PACIFIC GAS AND ELECTRIC COMPANY PG&E Ref. DRU14128-Case-Electric Undergrounding Expediting Program-Senate Bill (SB) 884 Data Request OEIS Requester Event Ref. No. Requester DR No. Energy Safety-DR-EUP-24-08

Requester: Ralff Douglas, Kristin Request Date: August 08, 2024 Response Date: August 13, 2024

Figure 1. Illustrative example of two adjacent CPZs

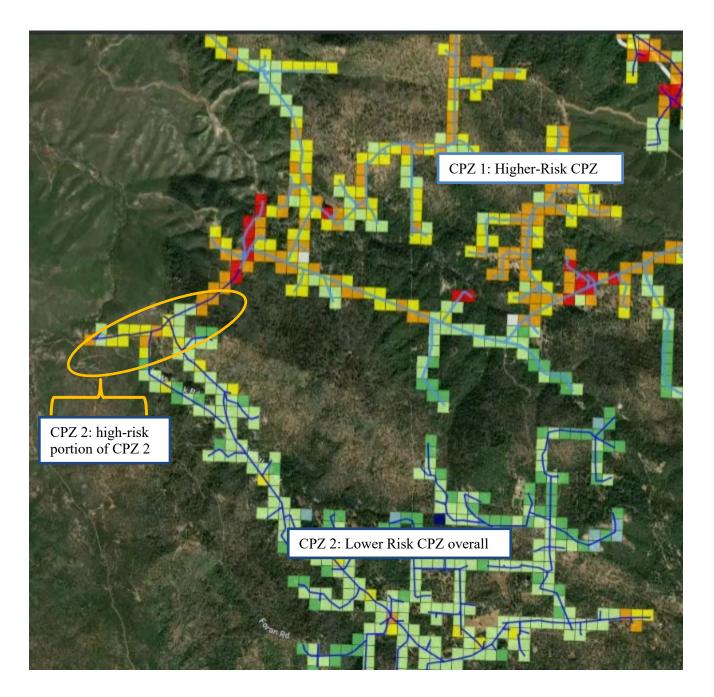
- e. What challenges would arise if Subprojects were restricted to take place only on pre-mitigation assets falling within this Project polygon?
- f. Currently, how commonly do subprojects extend outside the boundaries of the Circuit Segment on which they were qualified as high risk? By how far (as a percentage)? Would a Subproject ever take place entirely outside of the Circuit Segment on which it was qualified?

Yes, it is possible that a subproject could take place entirely outside of the Circuit Segment on which it was qualified. Figure 1 below visualizes an example for illustrative purposes. CPZ 1 (light blue line) was identified for mitigation due to having elevated risk for which the work is qualified. CPZ 2 (dark blue line) is a lower risk segment overall; however, the top portion of CPZ 2 shows the high-risk pixels that would be identified when scoping work on CPZ 1, thus included in the overall project for CPZ 1, and likely separated into its own subproject.
